February 22, 2021

**Re: Comments of Horizon West Transmission, LLC on the Draft Environmental Impact Report for the Estrella Substation and Paso Robles Area Reinforcement Project, December 2020 (California State Clearinghouse No. 2018072071)**

Estrella Substation and  
70 kV Power Line Components -  
Detailed View  
Sheet 2 of 8

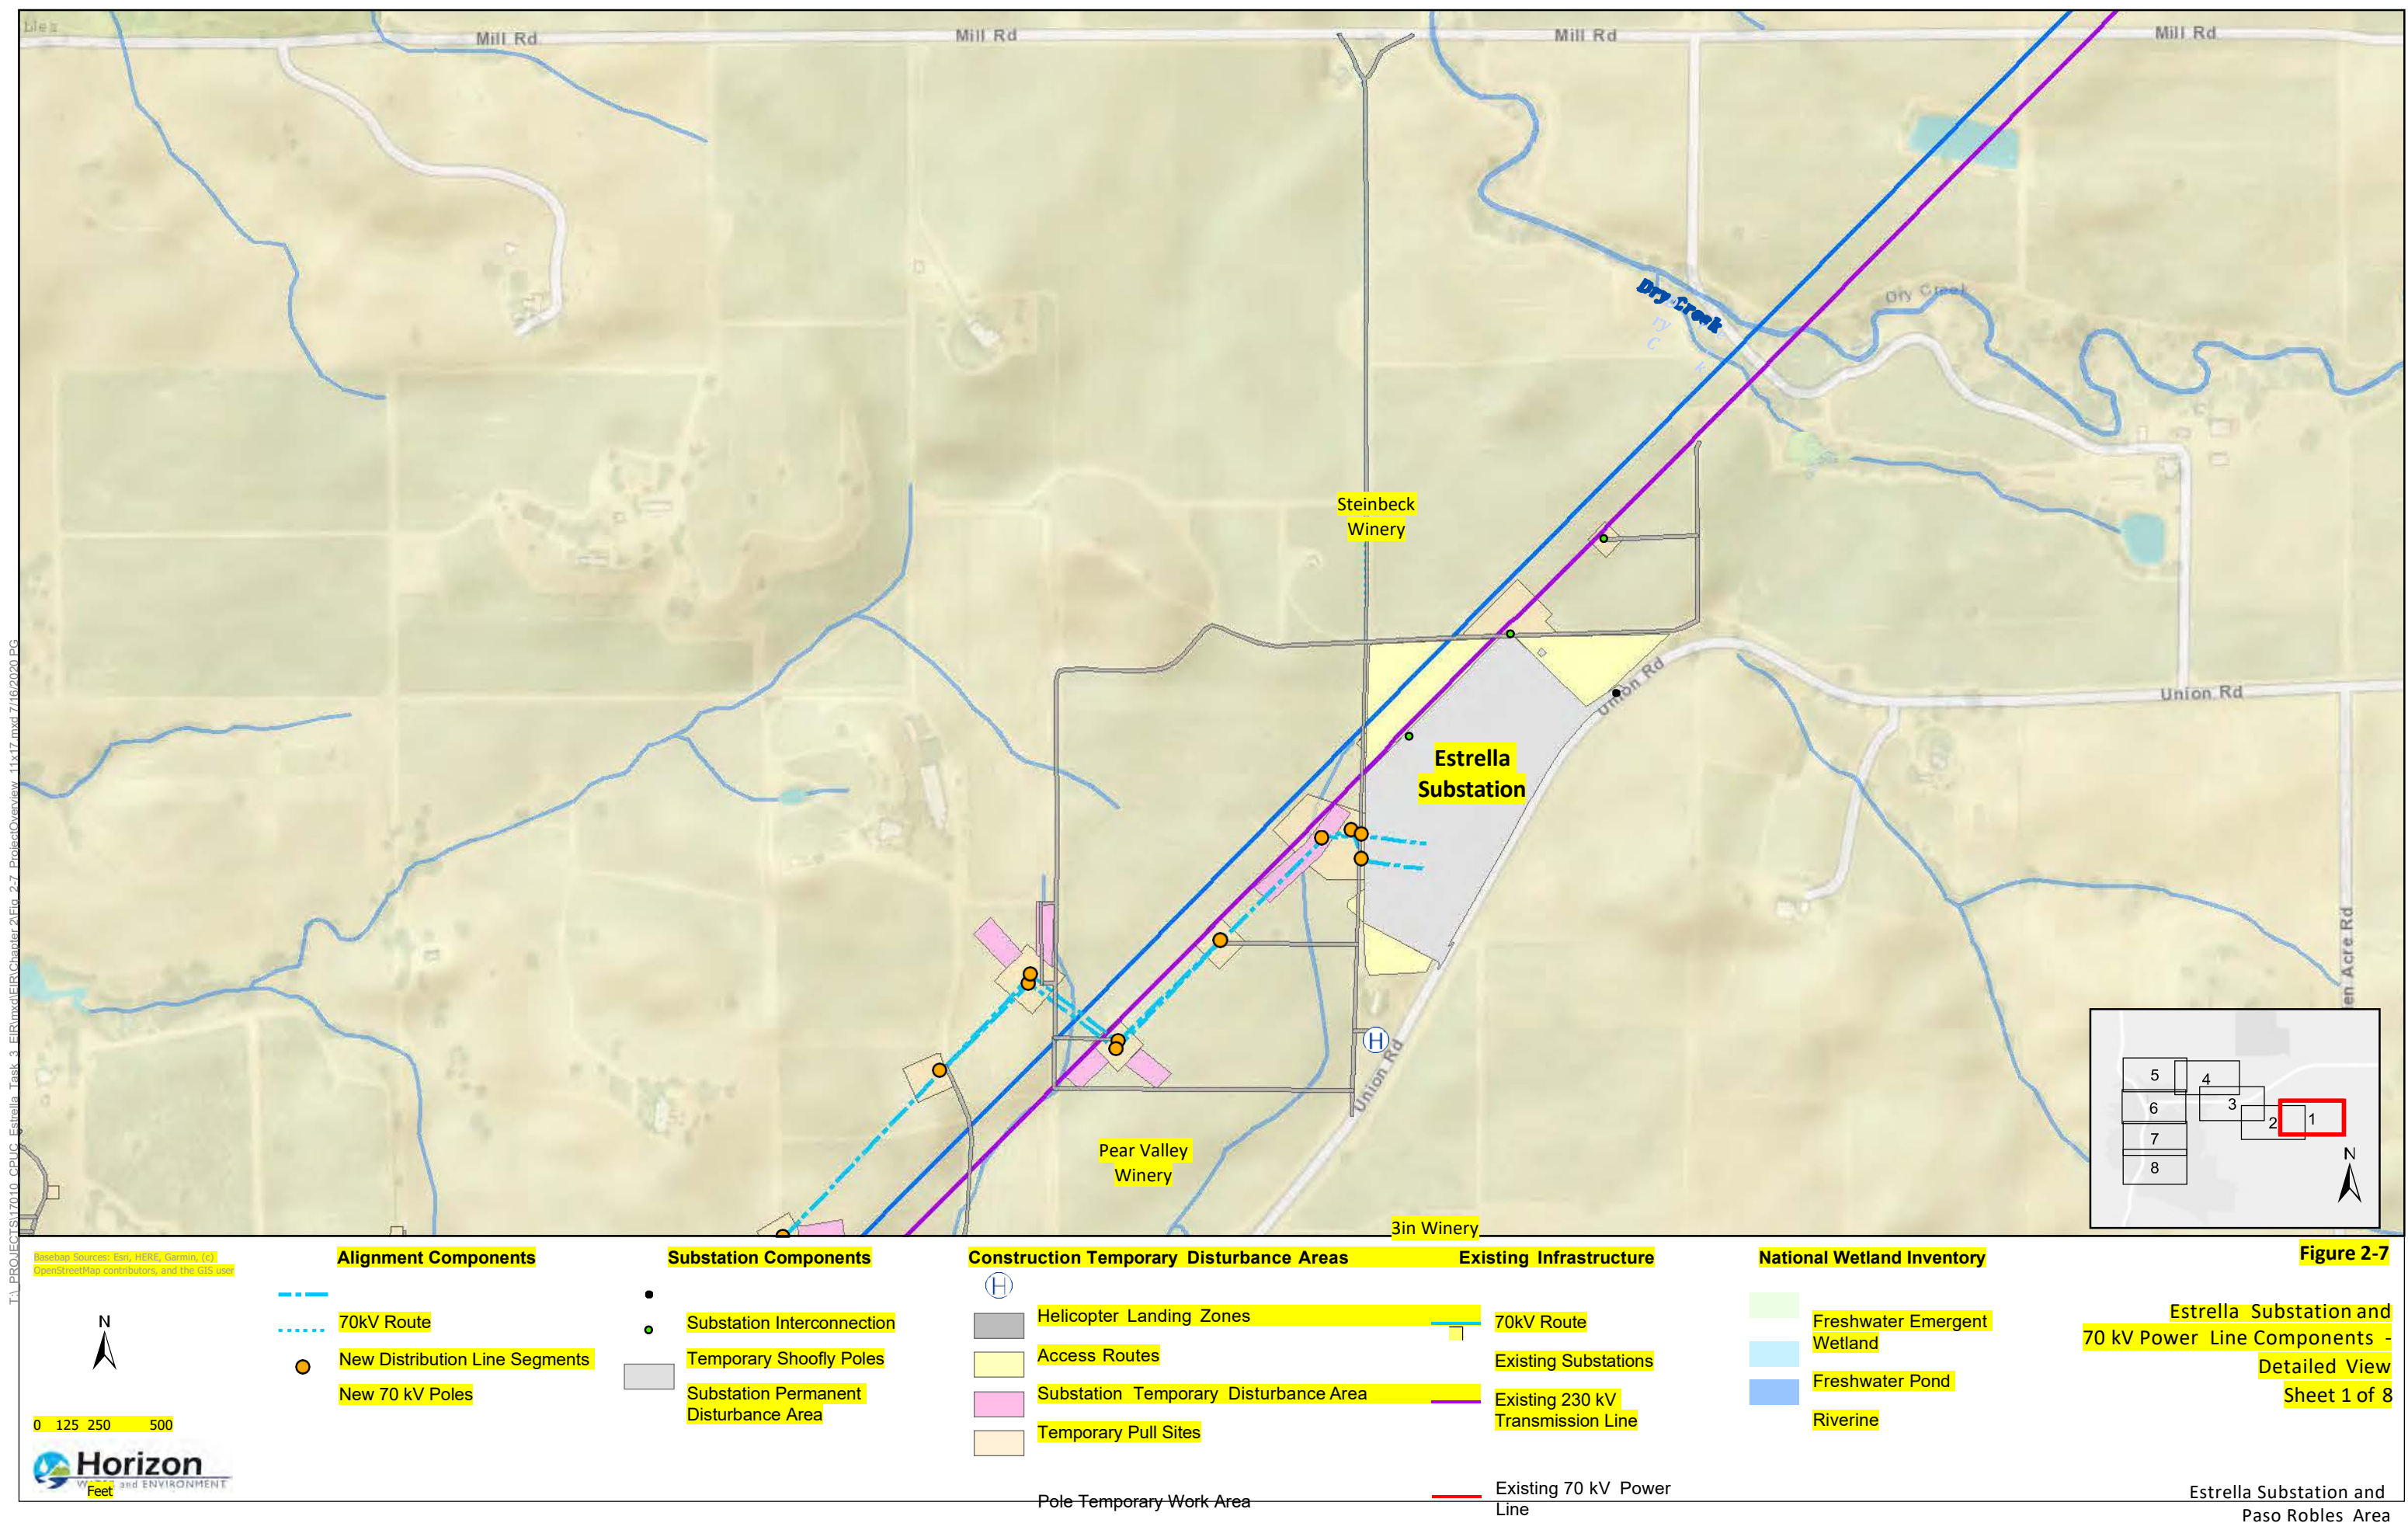
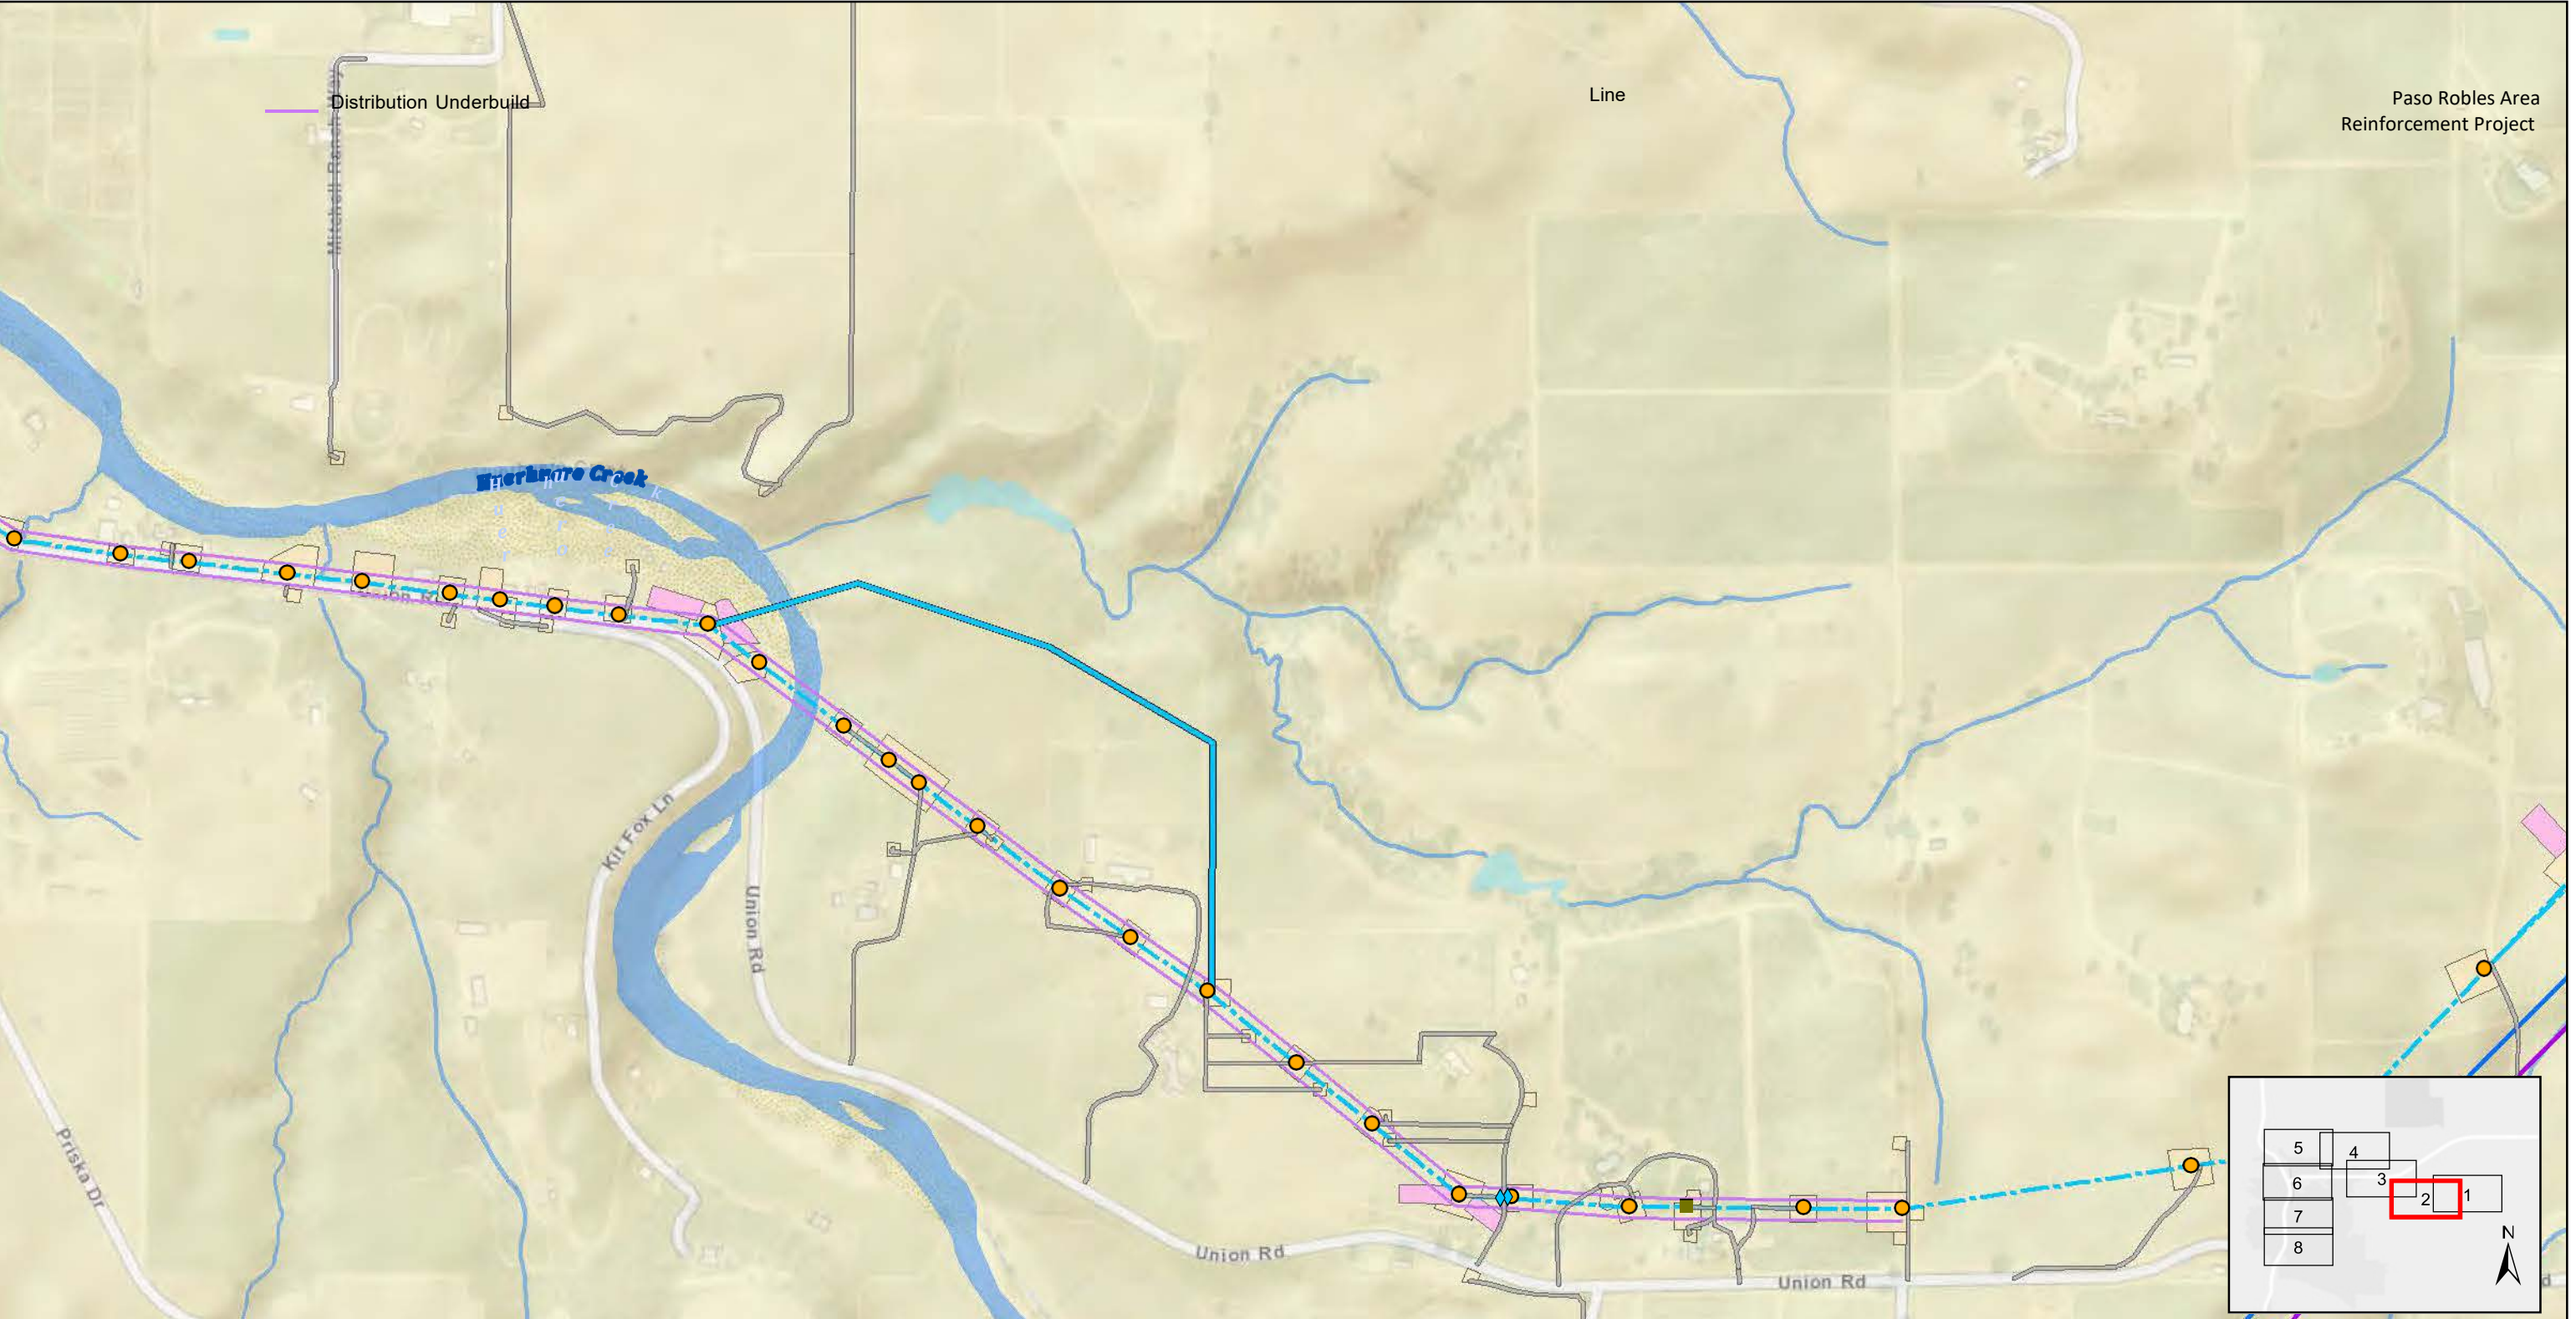
2-22	Figure 2-7	Replace figure to include new substation parcel and update temporary and permanent disturbance areas
2-46	Figure 2-11	Replace figure with new substation layout
2-47	Figure 2-12	Replace figure with new substation layout
2-48	Figure 2-13	Replace figure with new substation layout
2-49	The fenced portion of the 230 kV substation would be approximately 4 acres in size. An approximately 7-foot-tall chain-link fence with an additional 1 foot of barbed wire would be installed around the remaining perimeter of the 230 kV substation.	<p>Please revise text to read:</p> <p>The fenced portion of the 230 kV substation would be approximately 4 acres in size. <del>An approximately 7-foot-tall</del> chain-link fence, <u>a minimum of 7 feet tall</u>, with an additional 1 foot of barbed wire would be installed around the remaining perimeter of the 230 kV substation.</p>
2-56	The equipment and facilities associated with ultimate substation buildout would primarily be placed within the fence line of the already-constructed Estrella Substation. The anticipated layout of the Estrella Substation at ultimate buildout is shown in Figure 2-18. The additional 230/70 kV transformer under ultimate buildout is assumed to include the same amount of mineral oil (16,000 to 18,000 gallons) as described for the Proposed Project (see Section 2.3.1), and the same secondary containment structure (i.e., designed to allow sufficient freeboard to include the oil volume of the transformer plus the precipitation from a 25-year, 24-hour storm event). The additional 230 kV interconnection is assumed to include similar structures (LSTs) and follow a similar interconnection process to that described for the Proposed Project in Section 2.3.1 under the header for “230 kV Transmission Interconnection.” The additional 70/21 kV transformers that may be installed to support additional distribution feeders are assumed to include secondary containment, as necessary to contain spills of any stored mineral oil.	<p>Please revise text to read:</p> <p>The equipment and facilities associated with ultimate substation buildout would primarily be placed within the fence line of the already-constructed Estrella Substation. The anticipated layout of the Estrella Substation at ultimate buildout is shown in Figure 2-18. The additional 230/70 kV transformer under ultimate buildout is assumed to include the same amount of mineral oil (16,000 to 18,000 gallons) as described for the Proposed Project (see Section 2.3.1), and the same secondary containment structure (i.e., designed to allow sufficient freeboard to include the oil volume of the transformer plus the precipitation from a 25-year, 24-hour storm event). The additional 230 kV interconnection is assumed to include similar structures (LSTs) and follow a similar interconnection process to that described for the Proposed Project in Section 2.3.1 under the header for “230 kV Transmission Interconnection.” The additional 70/21 kV transformers that may be installed to support additional distribution feeders are assumed to include secondary containment, as necessary to contain spills of any stored mineral oil.</p>
